Project	IEEE 802.16 Broadband Wireless Access Working Group < http://ieee802.org/16 >	
Title	Remedy for relaying compressed DL-MAP/UL-MAP, HARQ-MAP and SUB-DL-UL-MAP	
Date Submitted	2007-07-19	
Source(s)	Kanchei (Ken) Loa, Yi-Hsueh Tsai, Hua-Chiang Yin, Shiann Tsong Sheu, Yung-Ting Lee, Youn-Tai Lee Institute for Information Industry 8F, No. 218, Sec. 2, Dunhua S. Rd., Taipei City 106, Taiwan Hongyun Qu, Mary Chion ZTE Corporation	Voice: +886-2-27399616 Fax: +886-2-23782328 loa@iii.org.tw qu.hongyun@zte.com.cn mchion@zteusa.com
Re:	IEEE 802.16j-07/019: "Call for Technical Comments Regarding IEEE Project 802.16j"	
Abstract	This contribution proposes the enhanced remedy of relaying compressed DL-MAP and UL-MAP, HARQ-MAP and SUB-DL-UL-MAP, which do not have MAC headers and management message types.	
Purpose	Text proposal for 802.16j Baseline Document.	
Notice	<i>This document does not represent the agreed views of the IEEE 802.16 Working Group or any of its subgroups. It represents only the views of the participants listed in the "Source(s)" field above. It is offered as a basis for discussion. It is not binding on the contributor(s), who reserve(s) the right to add, amend or withdraw

Figure xxx –Relaying DCD/UCD procedure

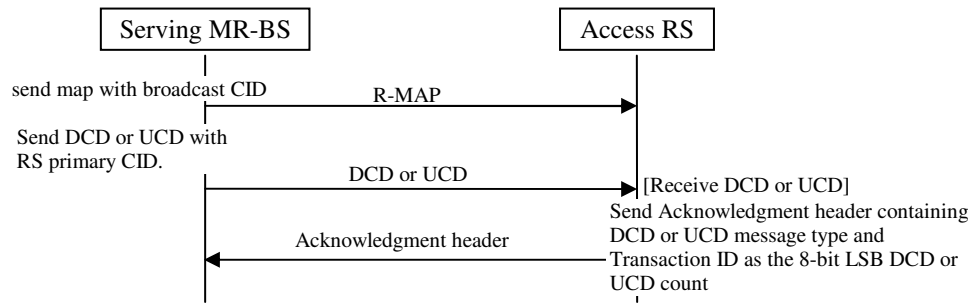
Upon receiving the DCD/UCD message with RS primary CID, as shown in Figure xxx, the RS shall acknowledge the reception of DCD or UCD messages over primary management connection by sending an acknowledgment header (See 6.3.2.1.2.2.2.3). The Transaction ID of the ACK header shall be set to the Configuration Change Count of DCD or UCD message. There shall be one ACK header per message. The RS may retransmit DCD/UCD message if the acknowledgement header is not received at the expiration of T52 timer.

Figure yyy – DCD/UCD broadcasting with centralized scheduling

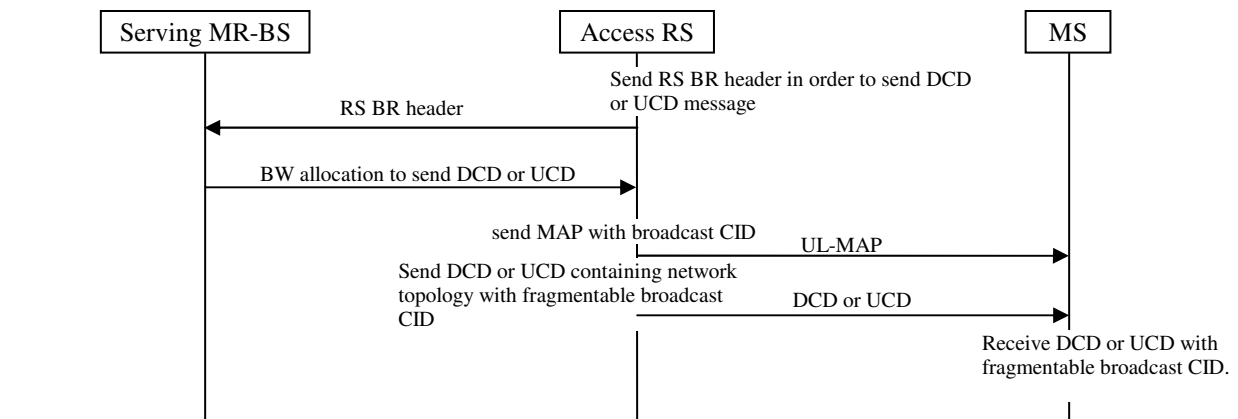
Under centralized scheduling, as shown in Figure yyy, the RS should request bandwidth on the access link to broadcast the DCD/UCD message with fragmentable broadcast CID.
